PINEVIEW HEIGHTS SUBDIVISION,
RESUBDIVISION OF LOTS 1 & 34

APPLICATION NUMBER 4 DATE August 6, 2015
APPLICANT Pineview Heights Subdivision, Resubdivision of Lots 1 & 34
REQUEST Subdivision

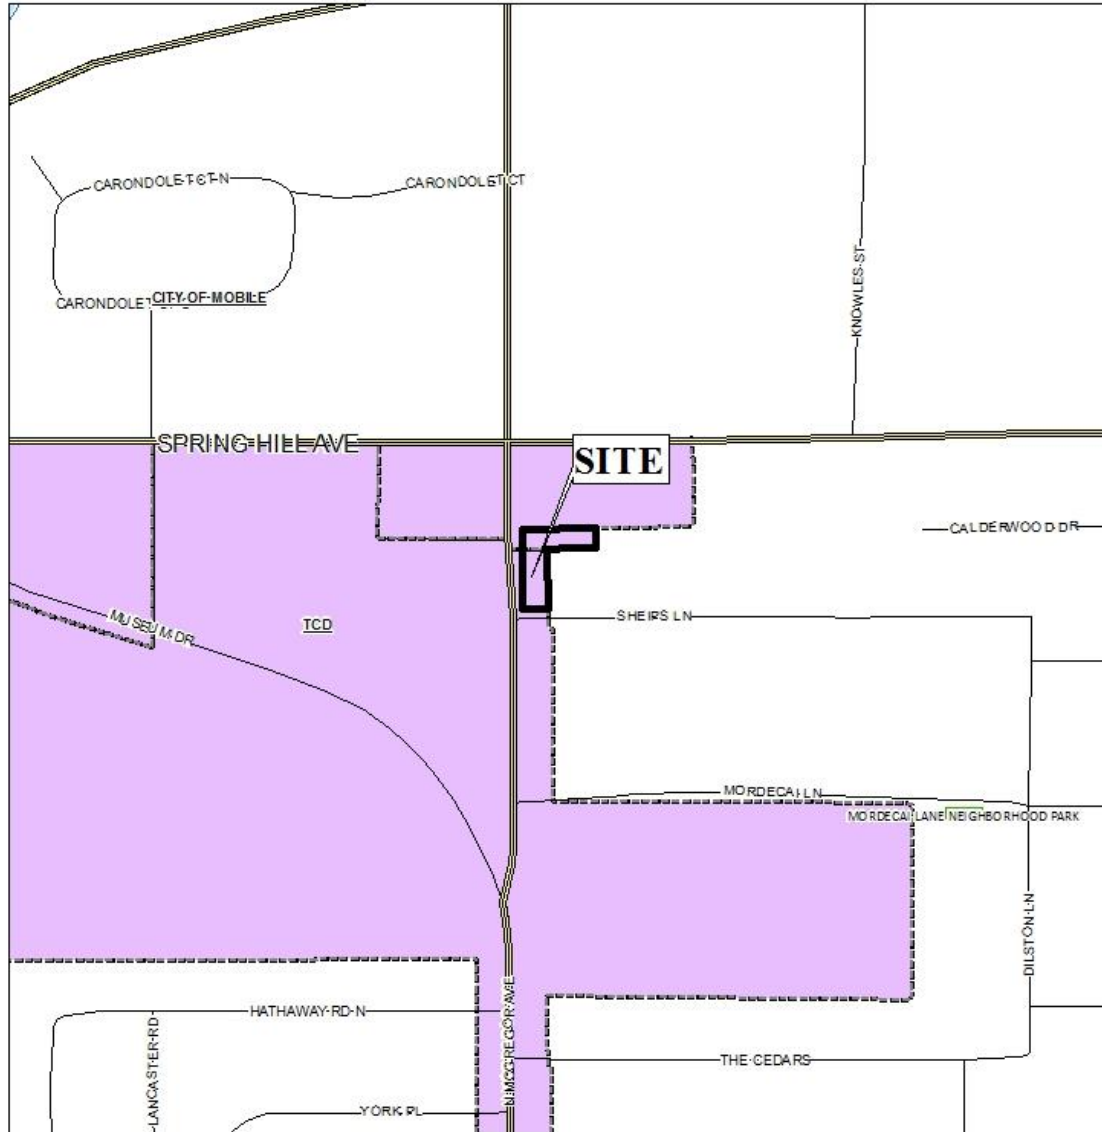
It should be noted that the preliminary plat includes labels on each lot with zoning districts: proposed Lot A is not within a B-1 district, but is also within an R-1, Single Family Residential district. The presence of the Neighborhood Center overlay is what allows the residentially-zoned property to be used for commercial development under the Traditional Center District zoning regulations. Therefore it is recommended that the zoning information be removed.

No setbacks are shown on the preliminary plat. Setbacks within the Traditional Center District are defined in the Zoning Ordinance, not the Subdivision Regulations. Given that development within the Traditional Center District is optional, a note should be placed on the plat stating that setbacks for Lots A and B shall be per Zoning Ordinance requirements.

Regarding street access, each lot should be limited to one curb-cut each, with the size, design and location to be approved by Traffic Engineering and comply with AASHTO standards.

- 1) Removal of the zoning district information for Lot A and Lot B from the plat;
- 2) Placement of a note on the plat stating: “Setbacks for Lots A and B shall be per Zoning Ordinance requirements”;

- 3) Placement of a note on the plat stating: “Each lot should be limited to one curb-cut each, with the size, design and location to be approved by Traffic Engineering and comply with AASHTO standards”;
